# UNITED STATES PATENT AND TRADEMARK OFFICE

## Office Action Summary

10/666,387

DETAILED ACTION

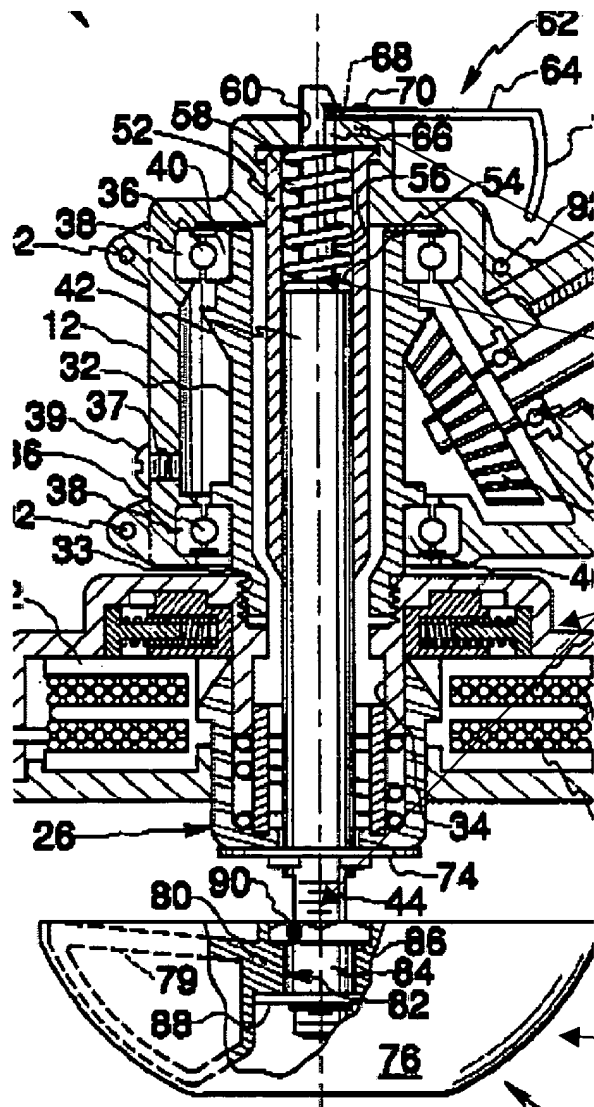
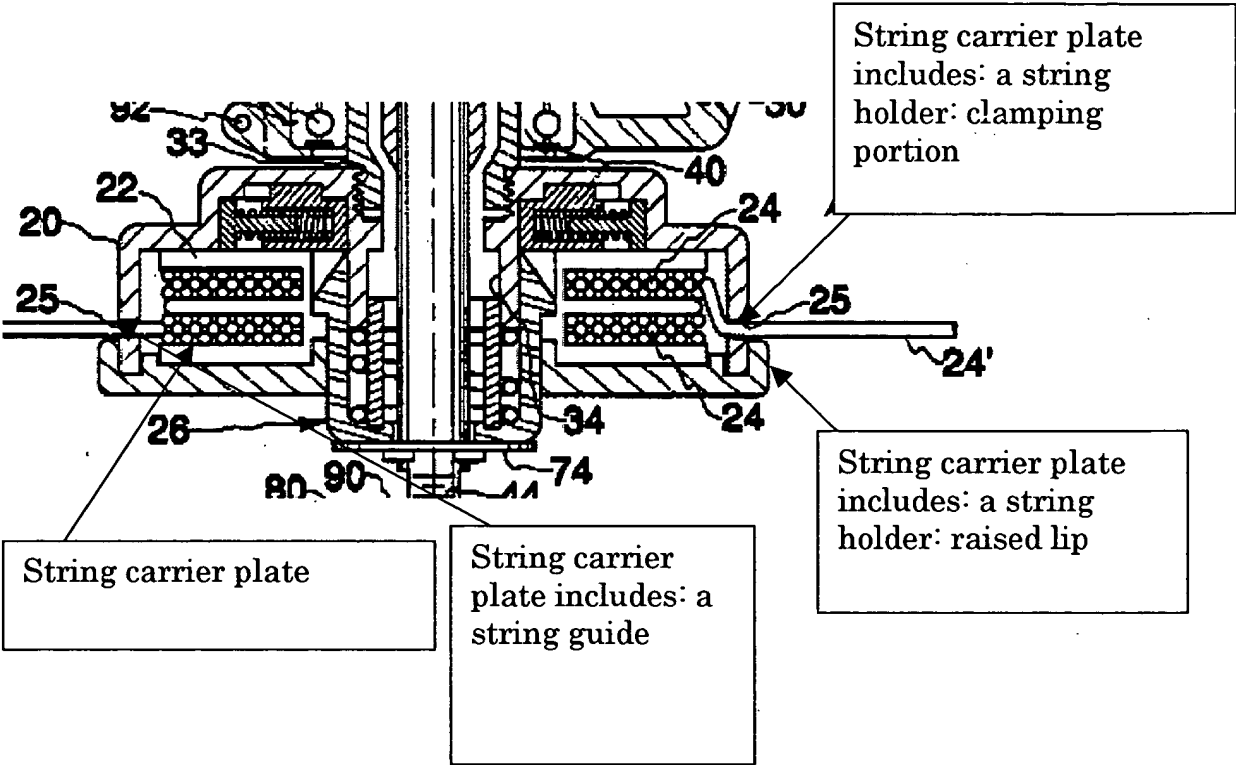
Nannen discloses:

in re claim 26:

a spindle housing & shaft & a string carrier for a cutting element (col. 3, ln. 49-52);

a mow ball rotatably connected to one end of the shaft (ground guide 50, col. 4, ln 64-67, col. 5, ln 1-4);

Grooved spindle shaft: an elongated keyway ref 66 in the reduced portion ref 56, adjustably connects the carrier assembly, as it is between the spindle housing & mow ball

Spindle housing

A string carrier

Mow ball

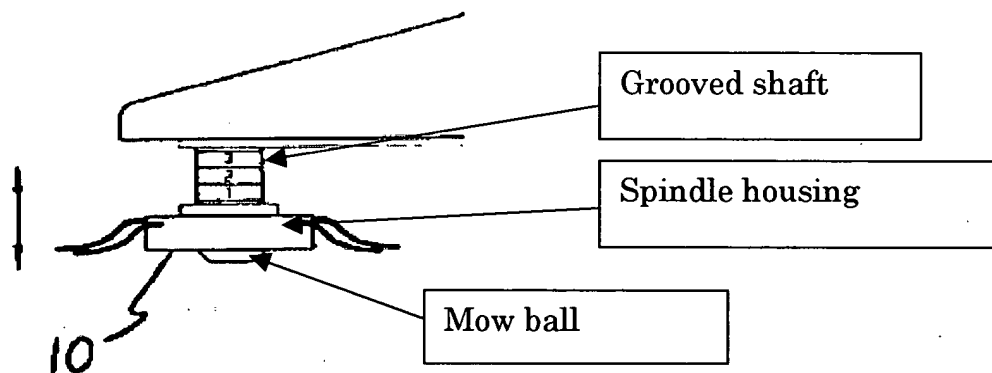
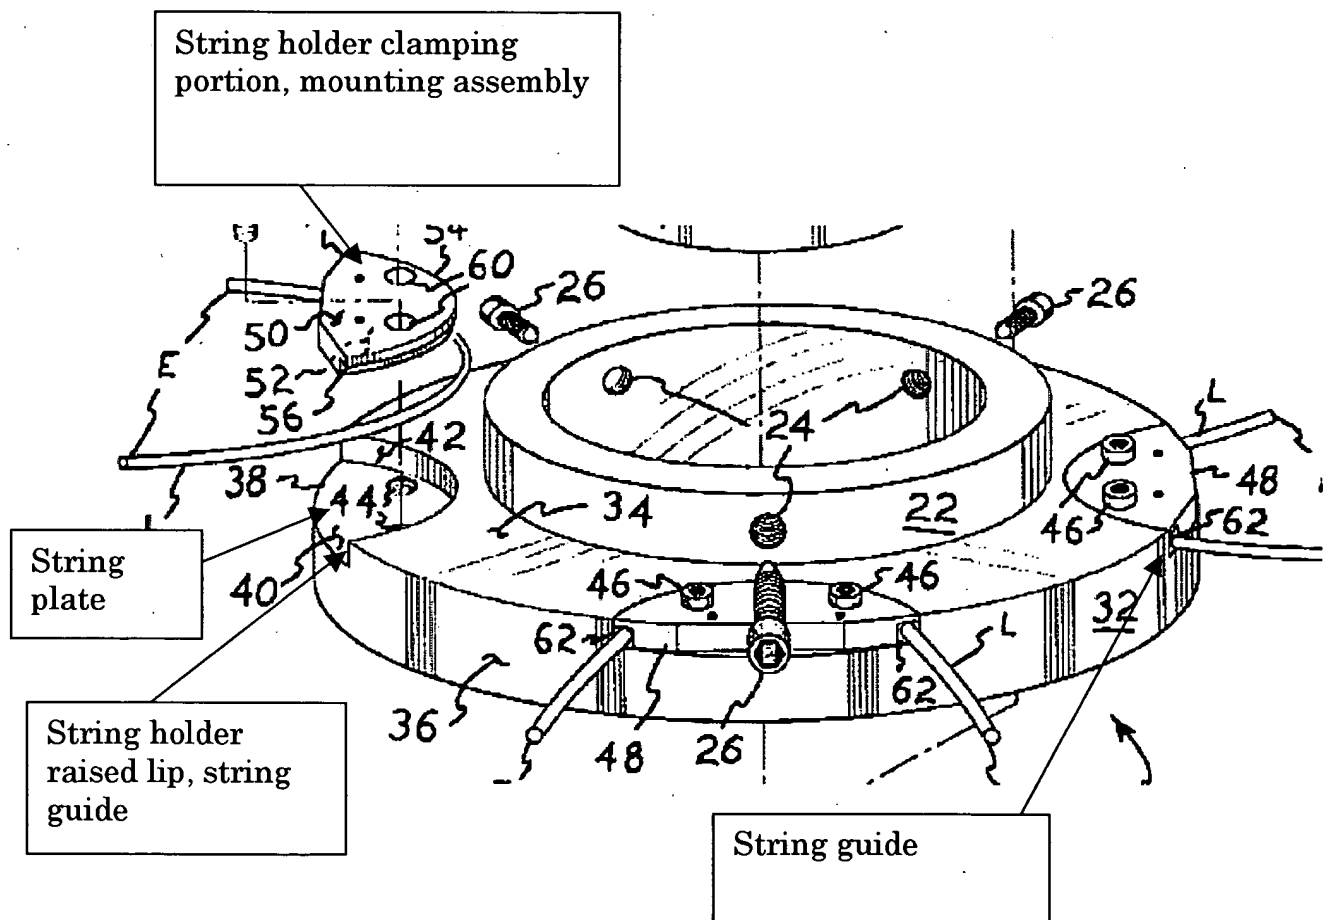
Harb discloses:

In re claims 26:

a spindle housing (10);

a grooved shaft or hub (12) rotatably coupled to the spindle housing;

a mow ball is shown at the lower end of the hub, however the rotatable connection between the hub/shaft to the mow ball is inherent (similar structure as in Nannen above);

a string carrier assembly (14) connected to the spindle shaft/hub intermediate the spindle housing and the mow ball (see fig 3);

In re claims 27-28, 30:

a string carrier plate, string guide, & strong holder: raised lip & clamping portion:

the string holder includes a raised lip portion (the upper part of 48) and a clamping portion (56);

the carrier assembly includes a mounting assembly (45) and a carrier plate (32);

the plate includes a string guide (between 56 & 42) and a string holder (48);

**FIG. 29.**

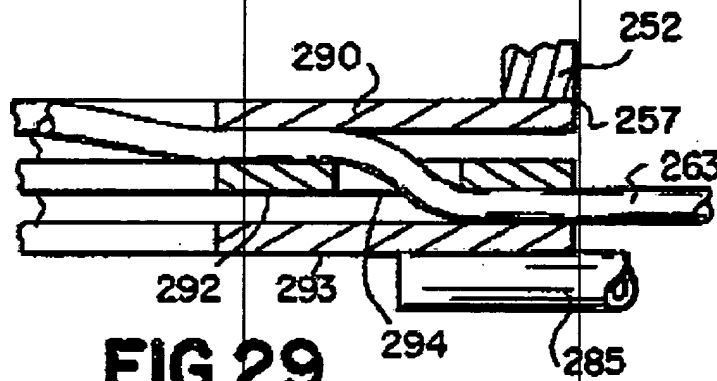
in re claim 29:

as best shown on fig 29, the design choice shape of the holder is unitary s-shaped (based on the shape of the string element).

Holder is shaped between this area, raised lip shown in biased state (cl.
